## **Important Notices**

## Restriction on Use of 8-bit Timers

## Datasheet Modifications: PWM Cycle of 8-bit Timers

Example when using PWM mode

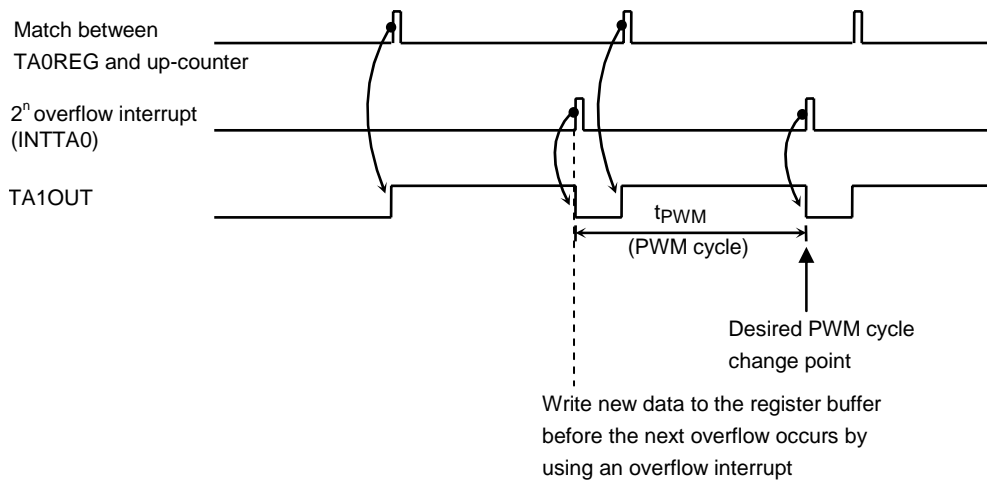
When the double buffer is enabled for an 8-bit timer in PWM or PPG mode, caution is required as explained below.

If new data is written to the register buffer immediately before an overflow occurs by a match between the timer register value and the up-counter value, the timer flip-flop may output an unexpected value.

For this reason, make sure that in PWM mode new data is written to the register buffer by six cycles ( $f_{sys} \times 6$ ) before the next overflow occurs by using an overflow interrupt.

In the case of using PPG mode, make sure that new data is written to the register buffer by six cycles before the next cycle compare match occurs by using a cycle compare match interrupt.
